11-AFC-4

Dr. Sönke Johnsen, Ph.D
Professor of Biology, Duke University

PSA equations for heating and cooling

I, Karen A. Mitchell, declare that on December 5, 2012, I served the attached *December 5 2012 CEC Workshop Presentation by Dr. Sonke Johnsen* via electronic and U.S. mail to all parties on the attached service list.

Absorptivity of feathers

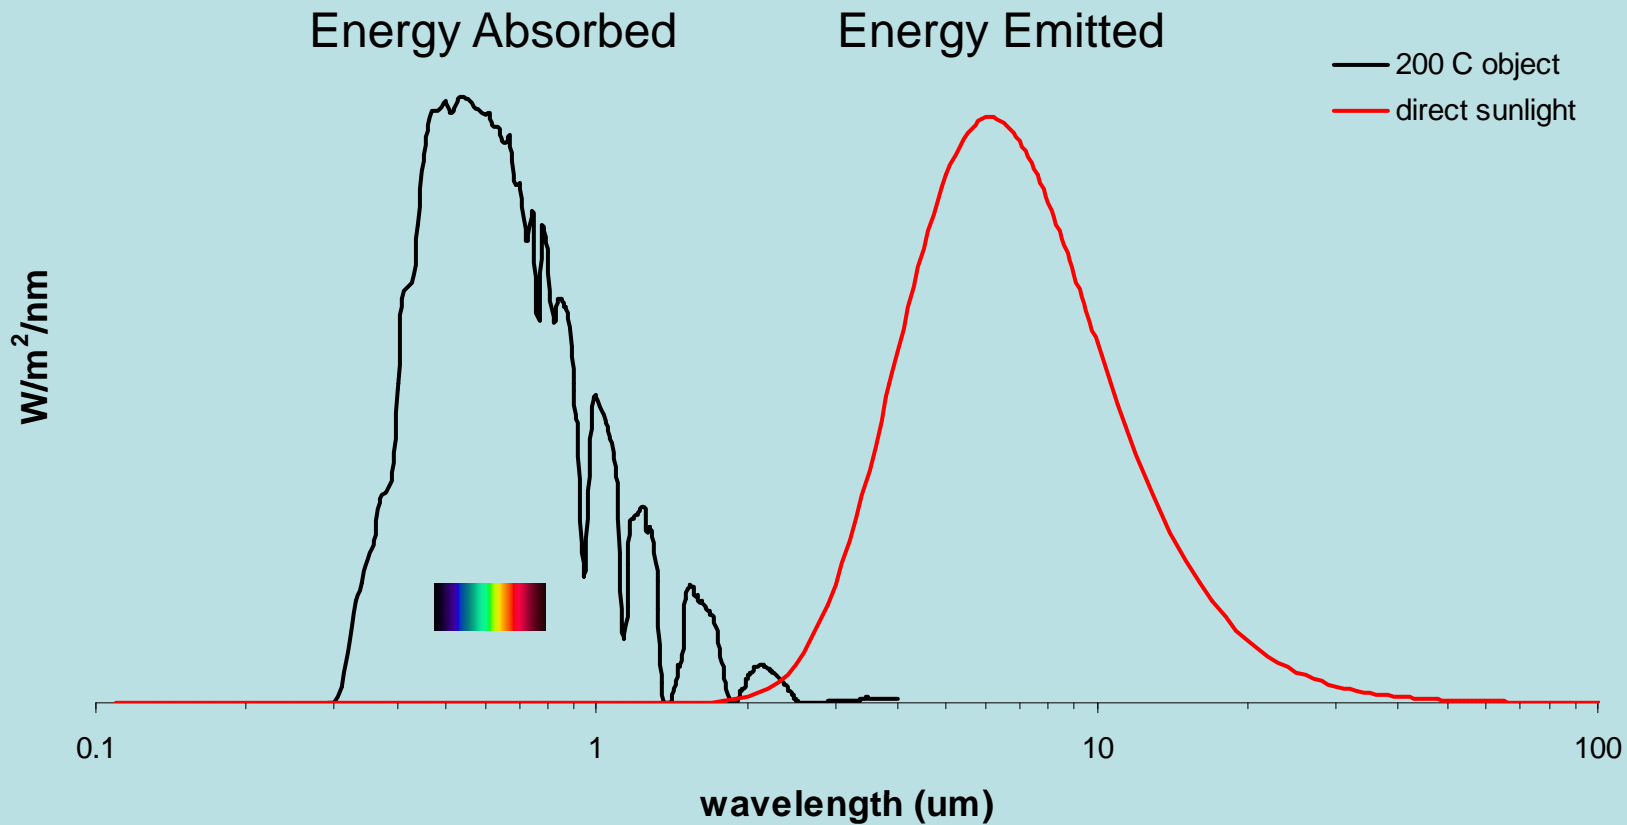
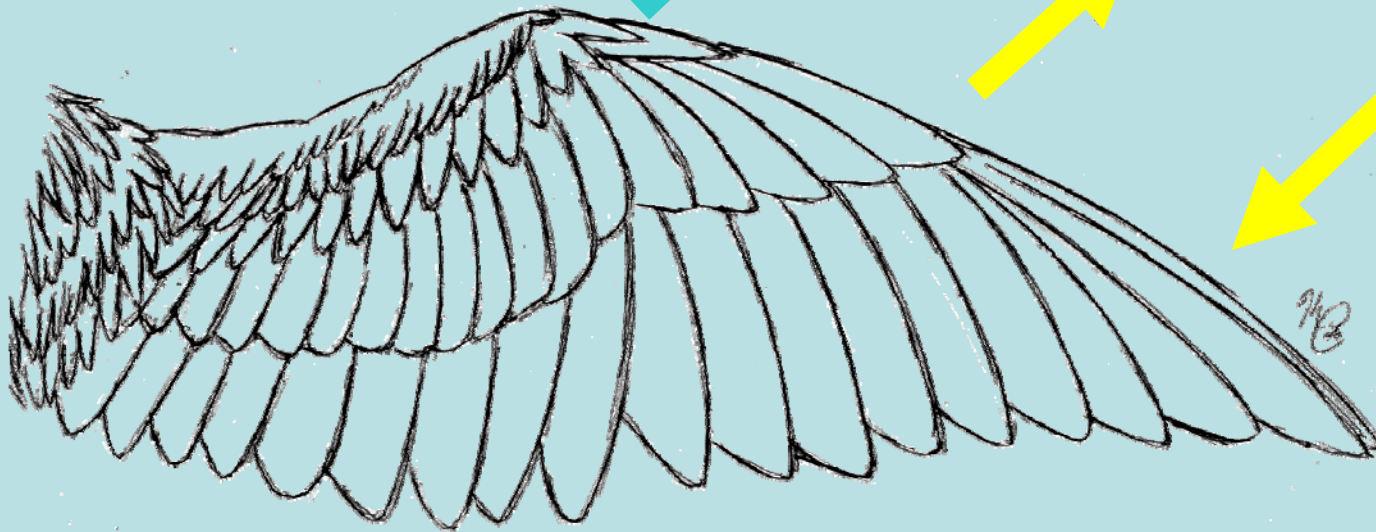
does $\alpha = \varepsilon$?

Spectra of sun and feather heated to 200 C

nearly all < 2um

nearly all > 2um

$$\alpha \neq \varepsilon$$

First correction of equations

$$Q_{SF} \cdot VF \cdot \alpha_{sol}$$

View Factor

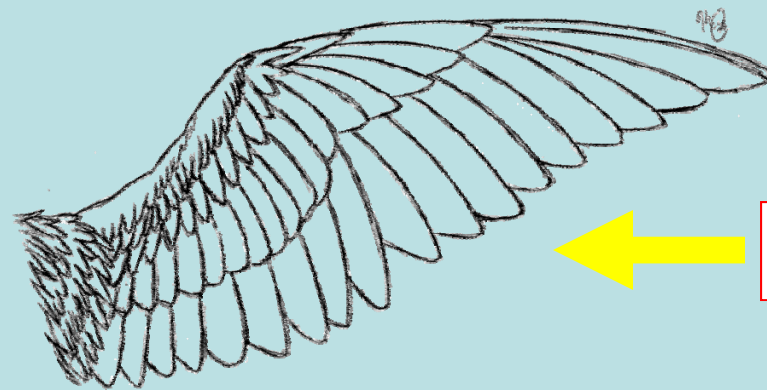
← (VF = 1)

versus

← (VF = 0.342)

| α_{sol} | Absorptivity correction | View Factor VF = 0.342 | | | |

Heat Transfer Coefficient h_c

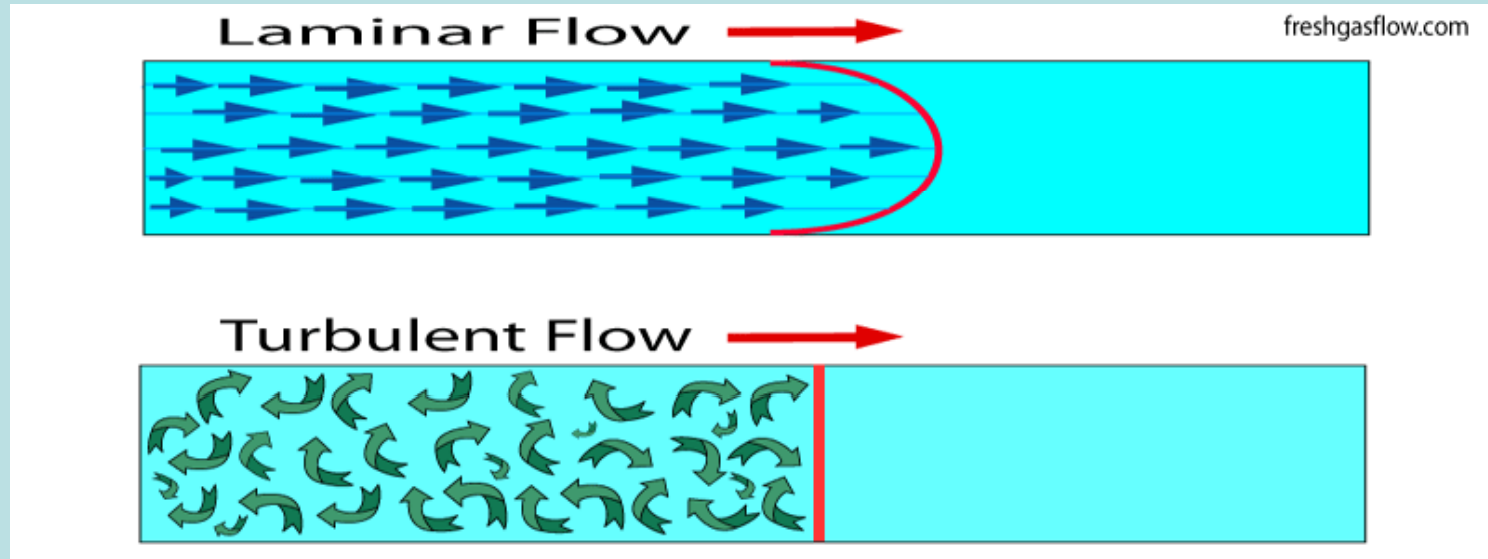
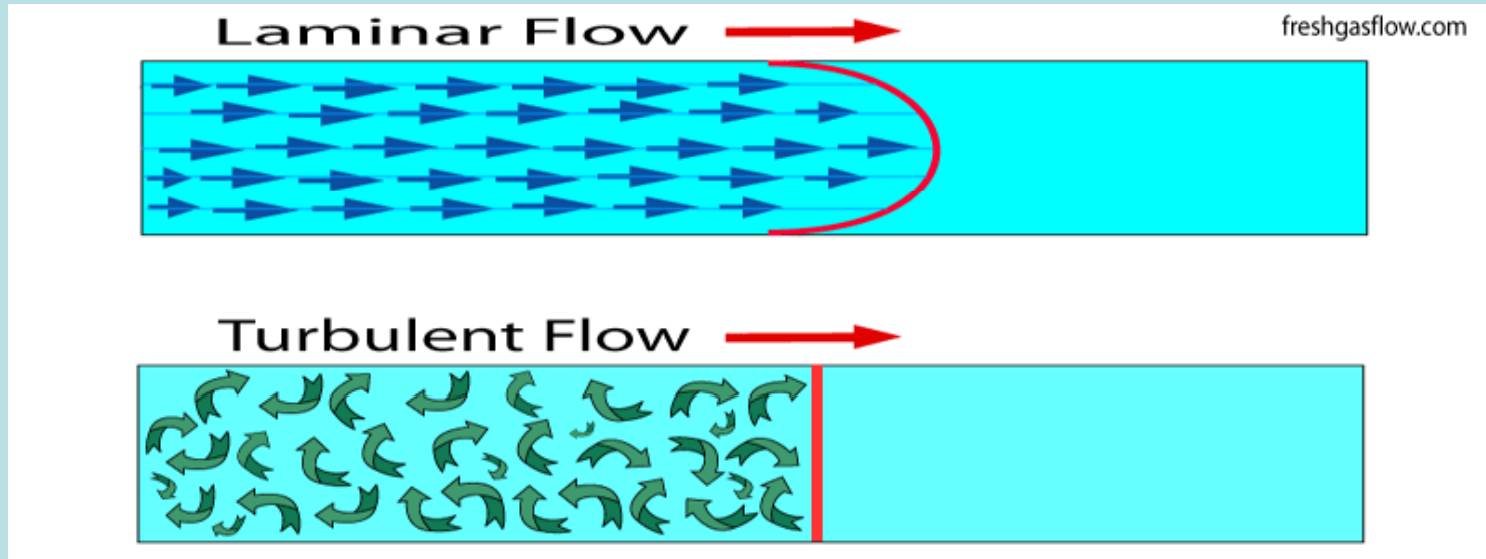
Laminar

versus

$$h_c = \frac{k_{air}}{L} Nu = 0.0592 \frac{k_{air}}{L} (Re)^{4/5} \sqrt[3]{Pr} \cong 71.8$$

Turbulent

$Re = \sim 68,000$ --- Turbulent flow

| α_{sol} | Absorptivity correction | View Factor VF = 0.342 | Heat Xfer Coef. $H_c = 71.8$ | | |

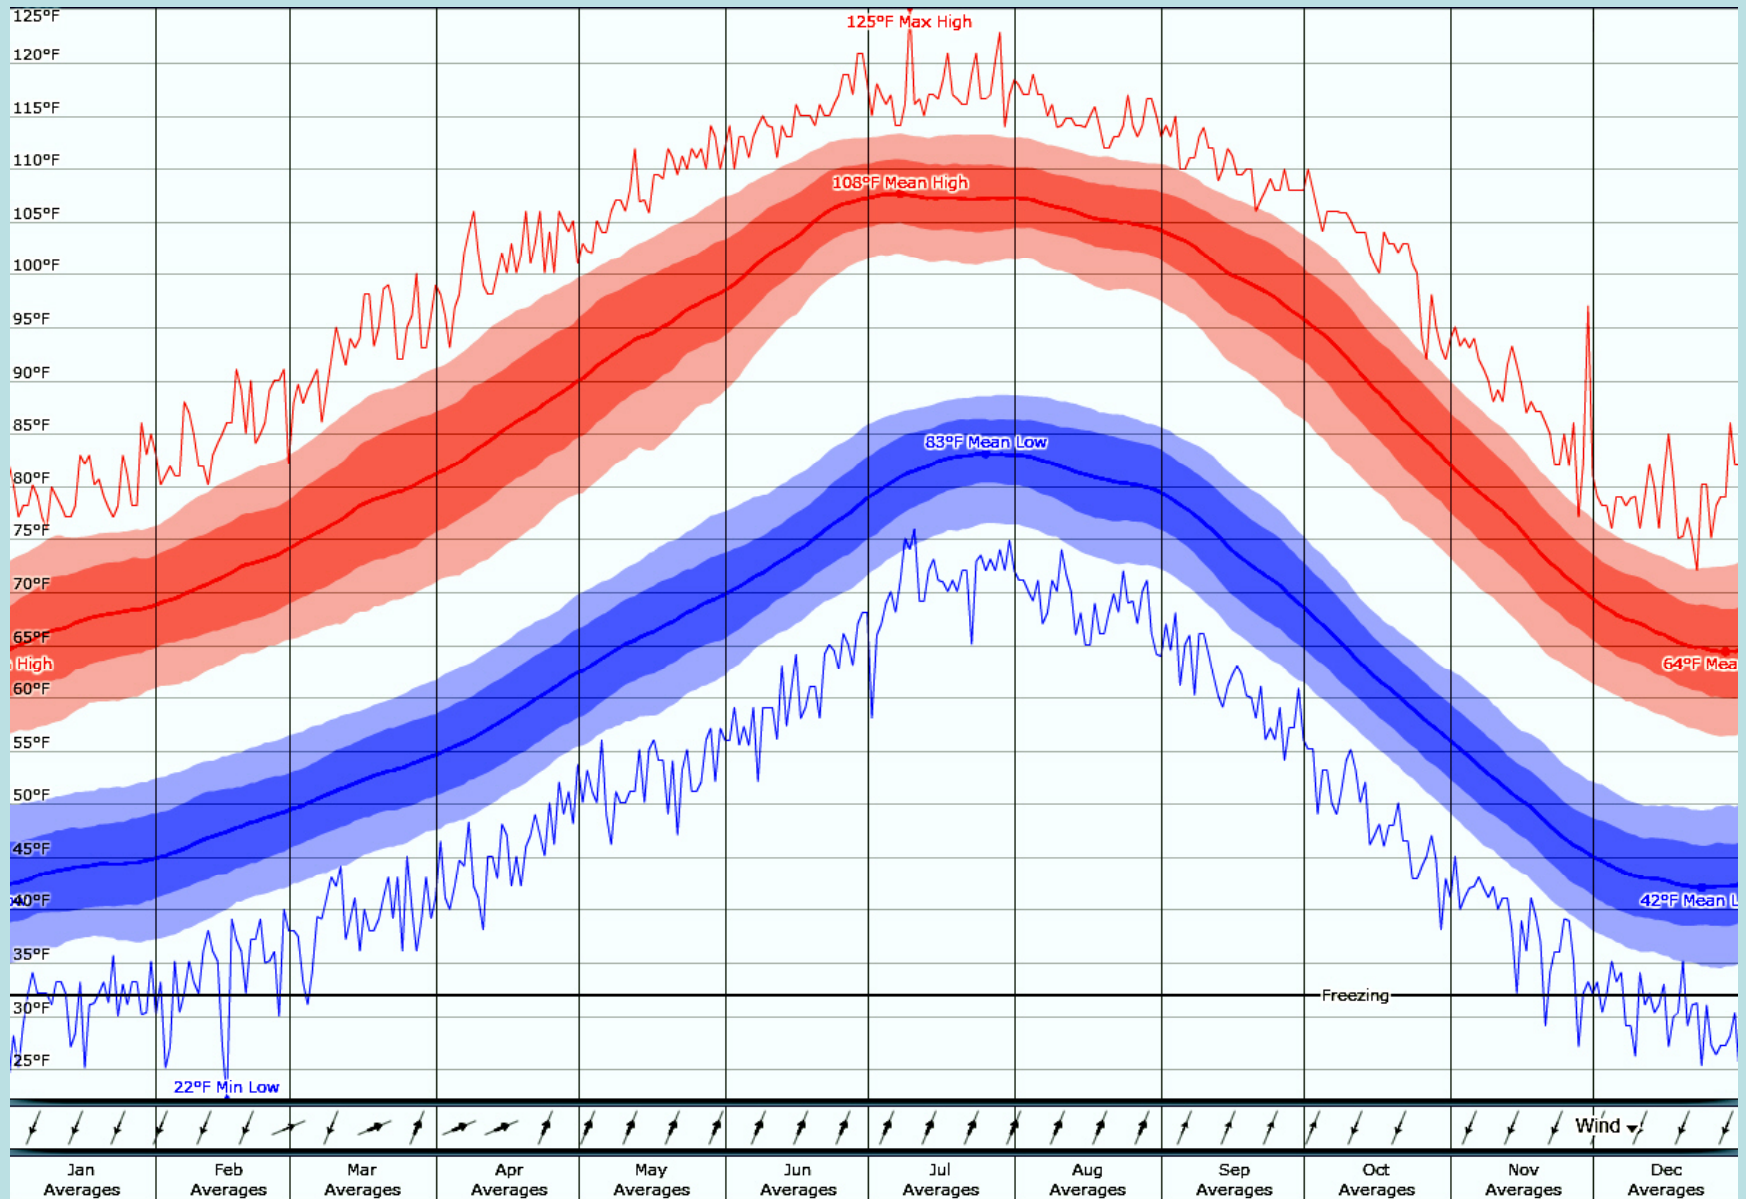
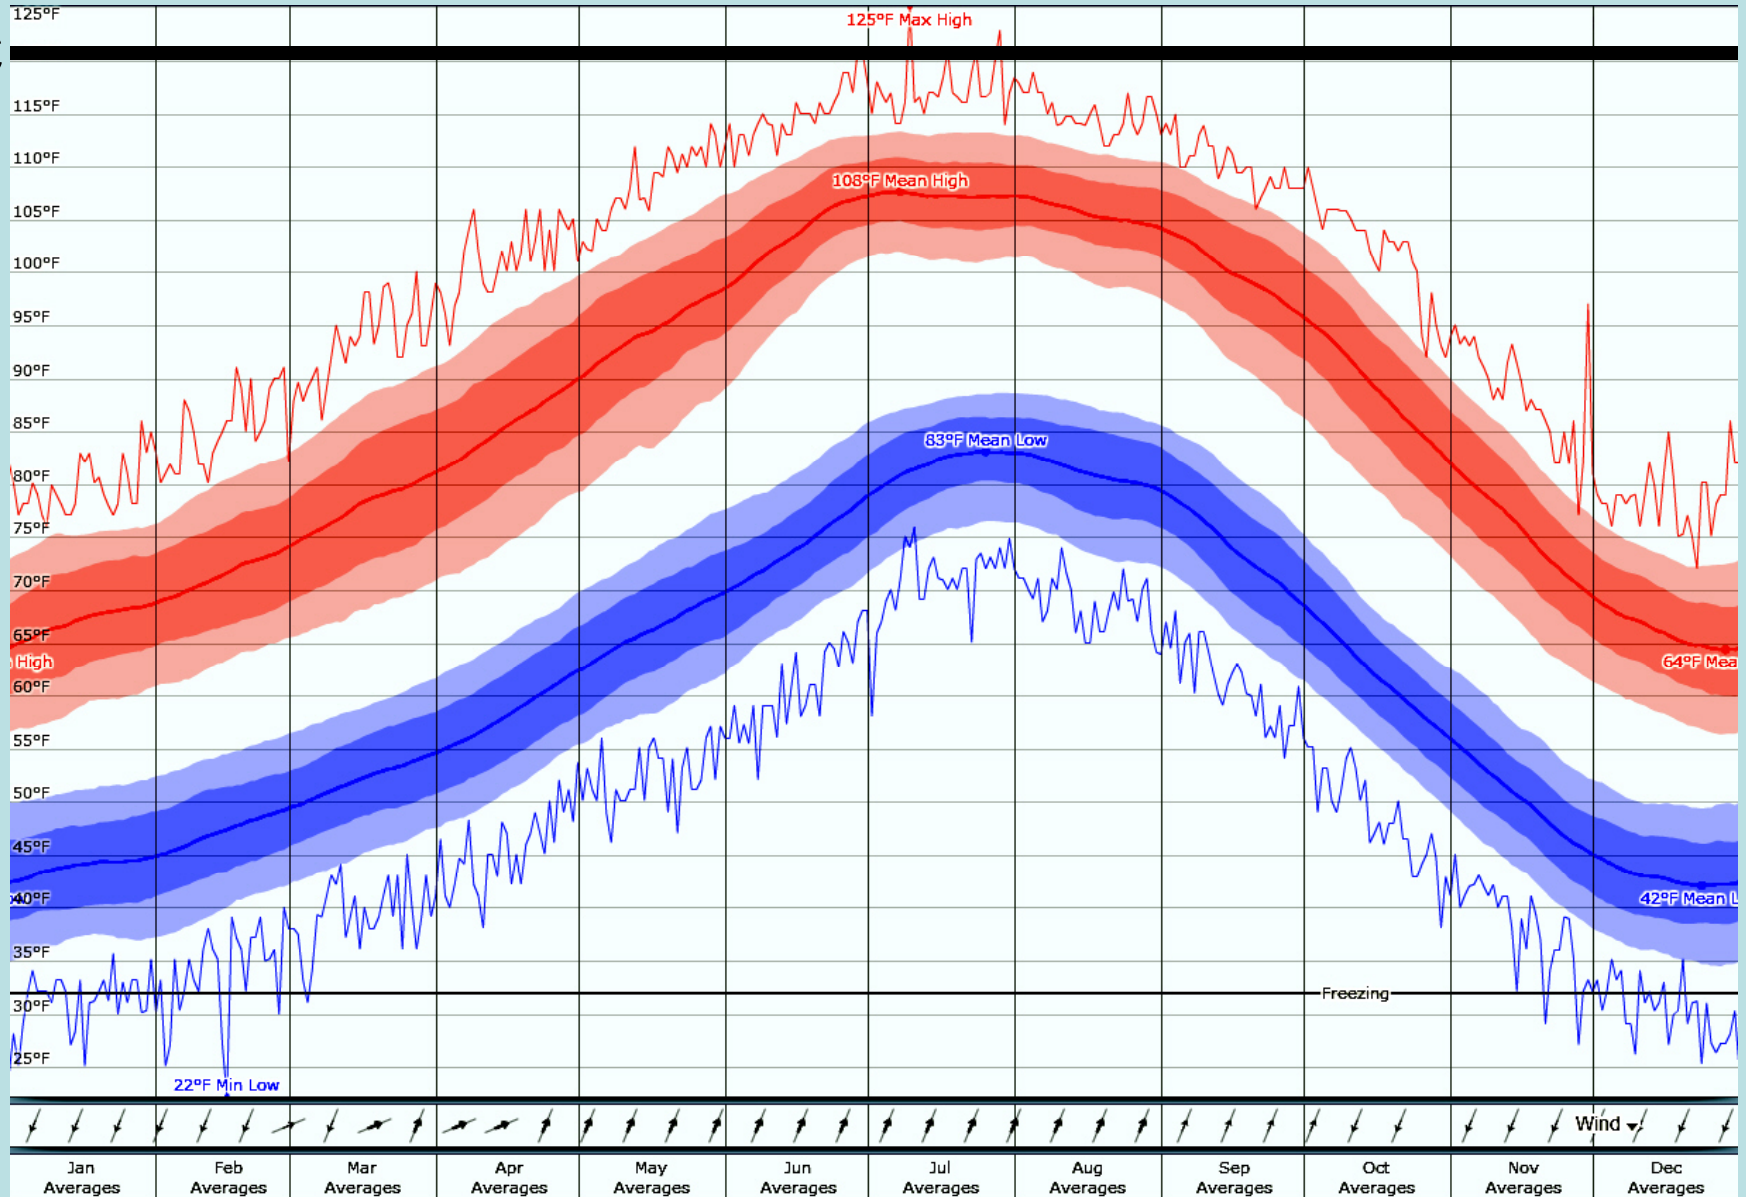
T_{air} = 49 C?

T_{air} = 49 C?

49 C

49 C
45 C

| α_{sol} | Absorptivity correction | View Factor VF = 0.342 | Heat Xfer Coef. $H_c = 71.8$ | Ambient Air $T_{air} = 45\text{ C}$ | |

Radiative heat loss

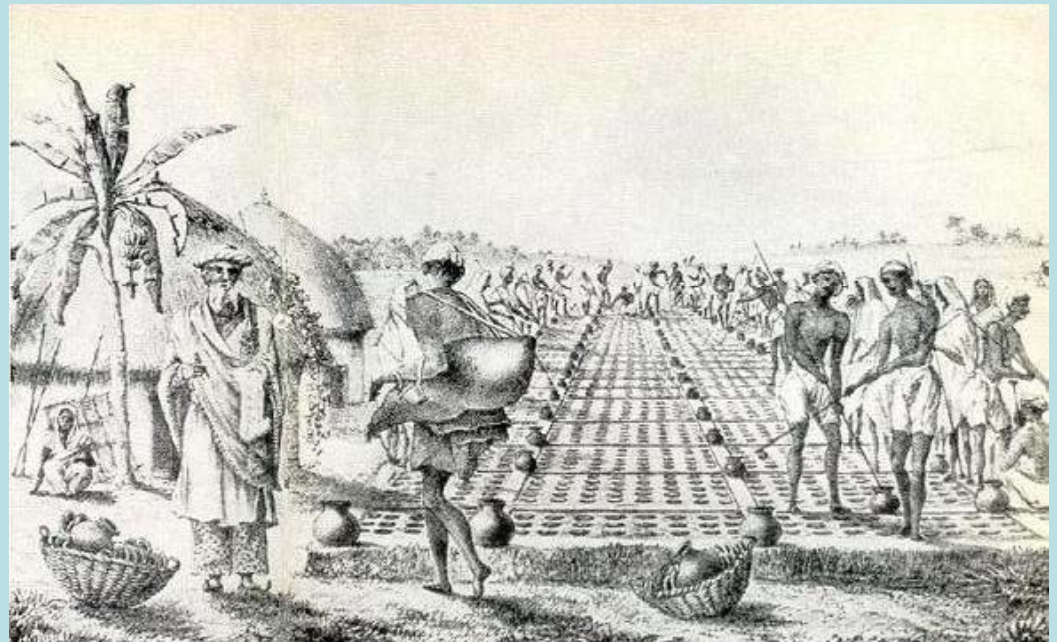
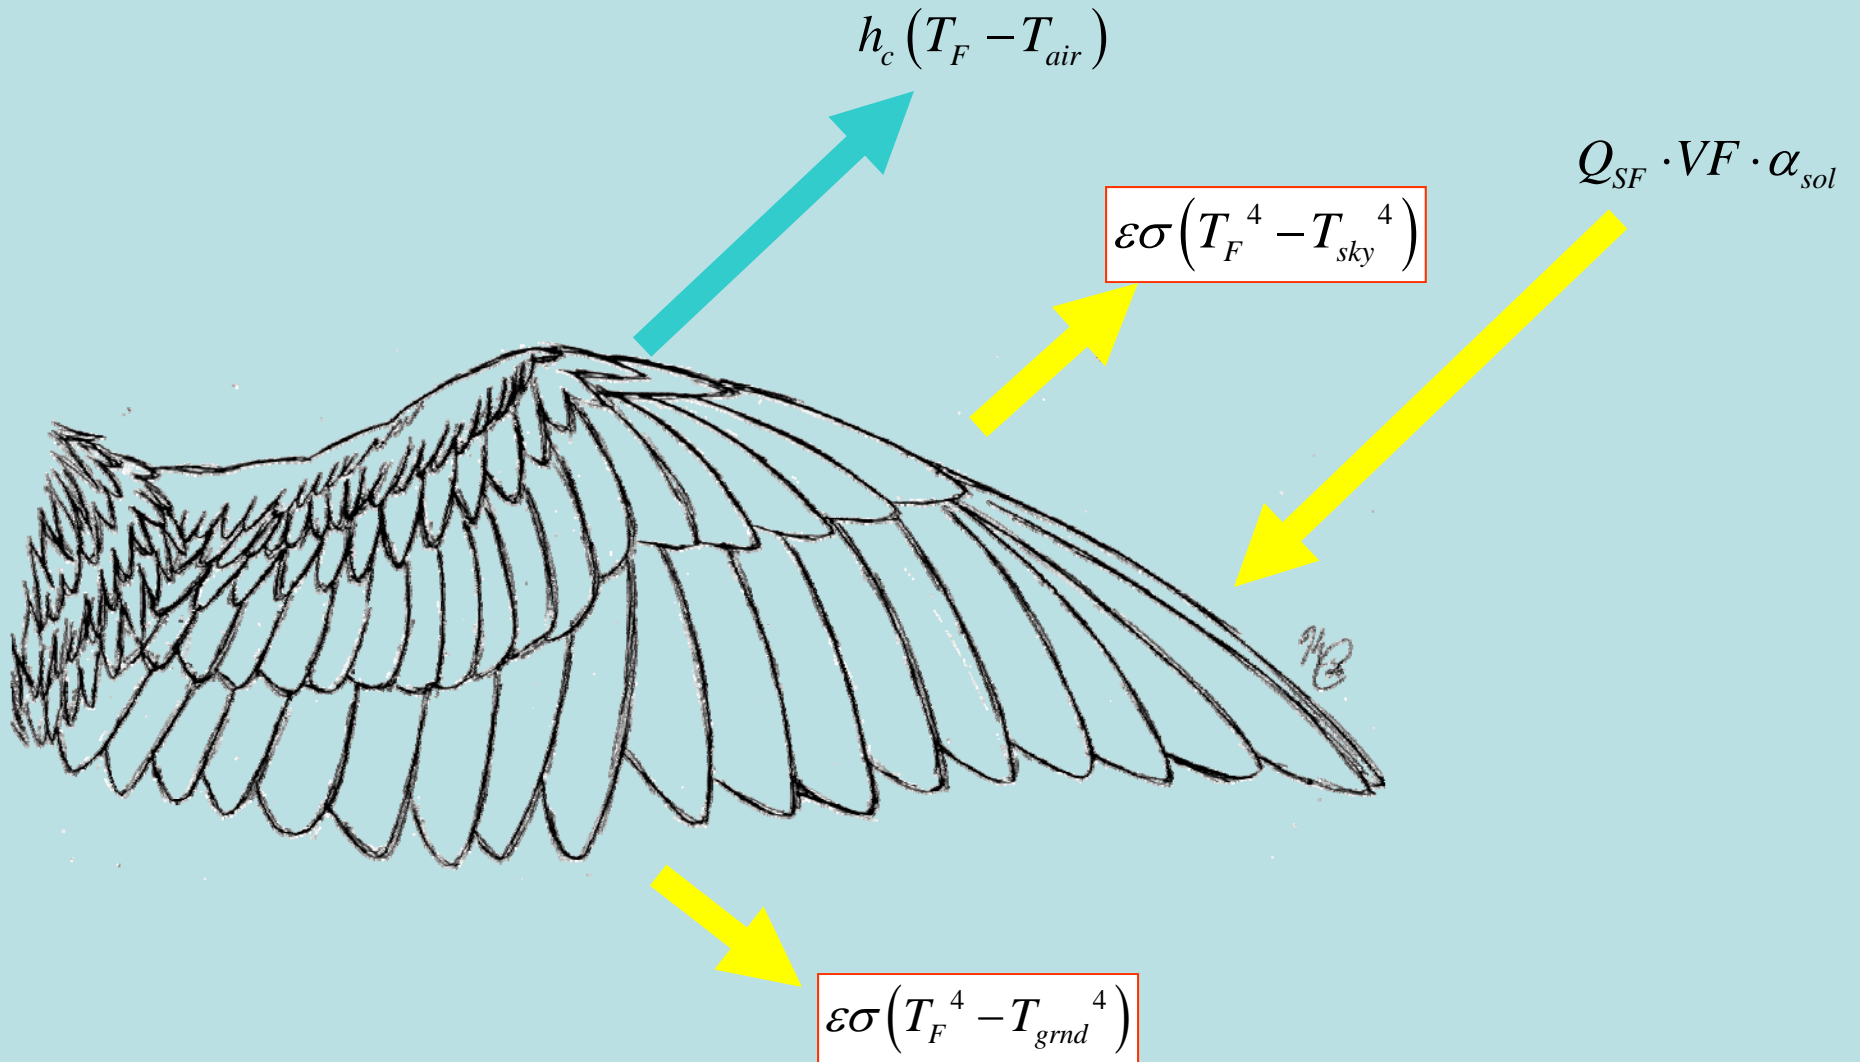
Radiative temperature versus Air temperature

$$\varepsilon\sigma (T_F^4 - T_{sky}^4)$$

$$\varepsilon\sigma (T_F^4 - T_{grnd}^4)$$

| α_{sol} | Absorptivity correction | View Factor VF = 0.342 | Heat Xfer Coef. $H_c = 71.8$ | Ambient Air $T_{air} = 45\text{ C}$ | $T_{sky} = 0\text{ C}$ $T_{grnd} = 45$ |
